**REMARKS****Status of the Claims**

The invention is directed to an assembly for retaining a boot on a gliding board, such as a snowboard.

FIG.1

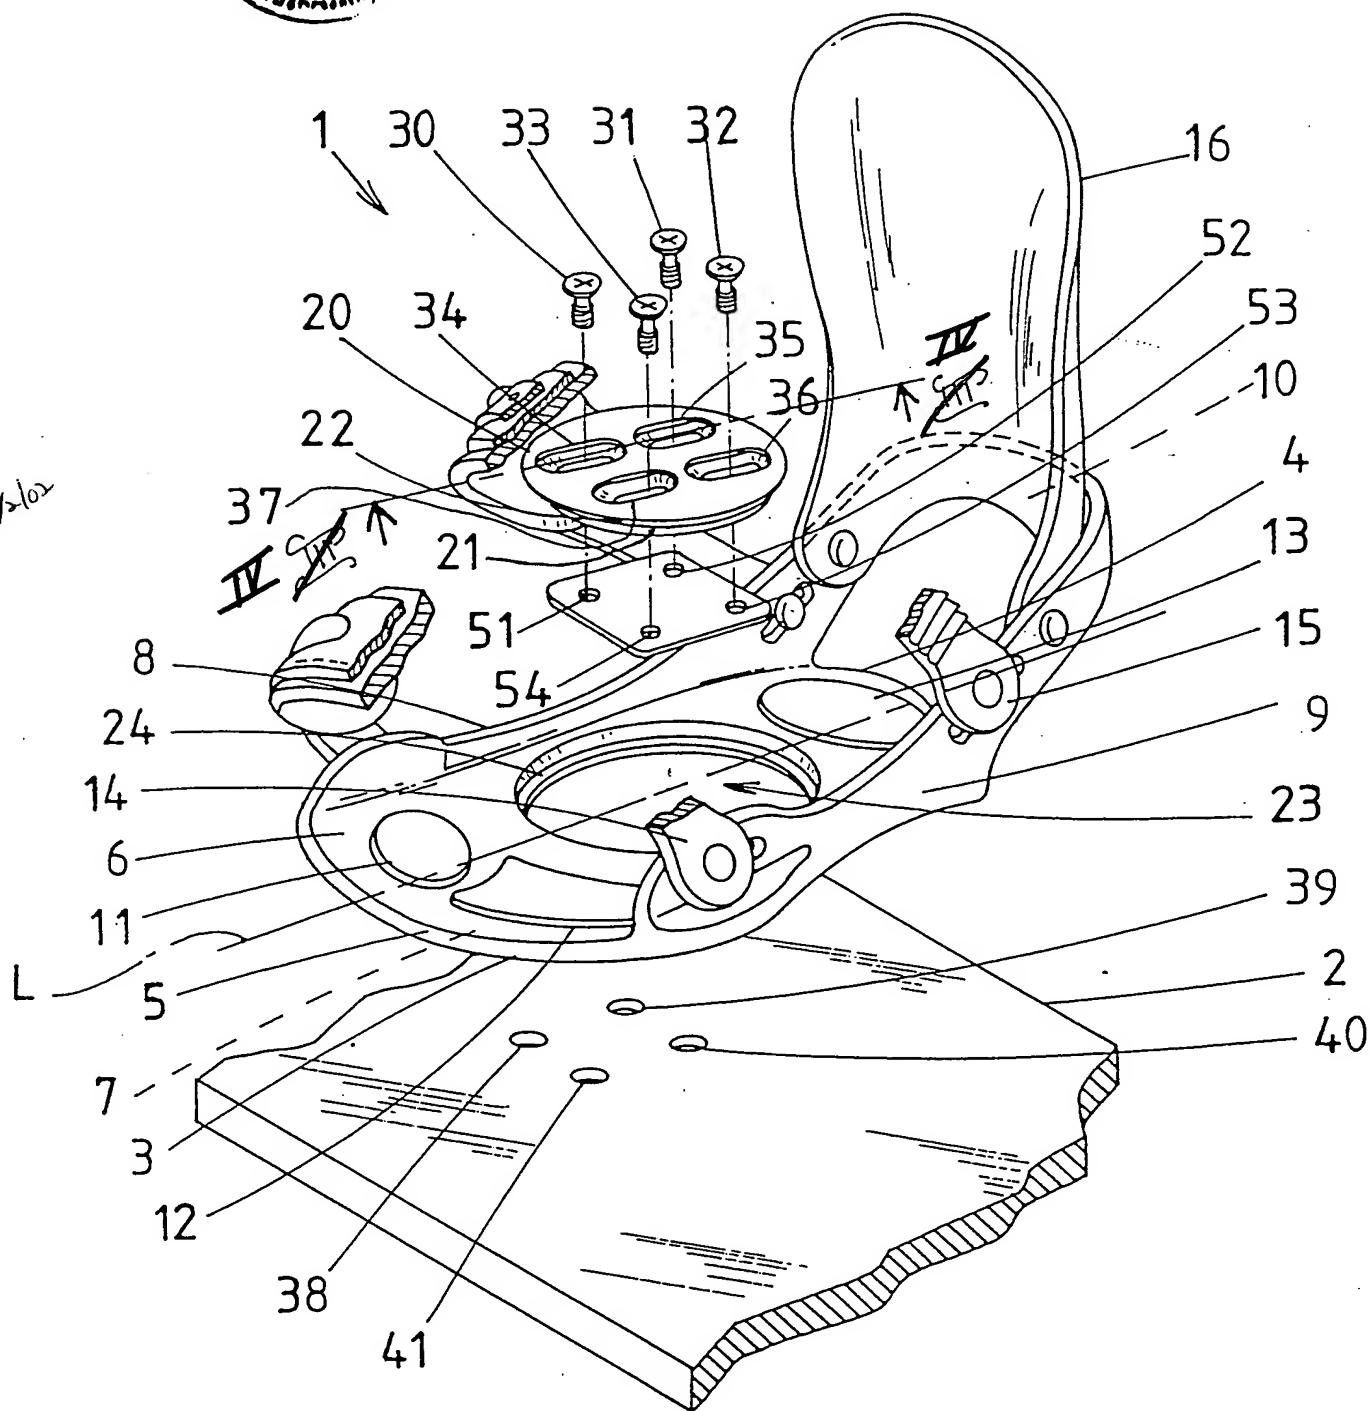
The specification is objected to for referring to line IV-IV of Fig. 1, inasmuch as Fig. 1 has no such line (although Fig. 1 includes line IV-IV).

In response to the objection to the specification, Applicants are filing concurrently herewith a Request for Approval of Proposed Drawing Correction, whereby the line III-III is to be changed to IV-IV, for consistency with the brief description of the specification.
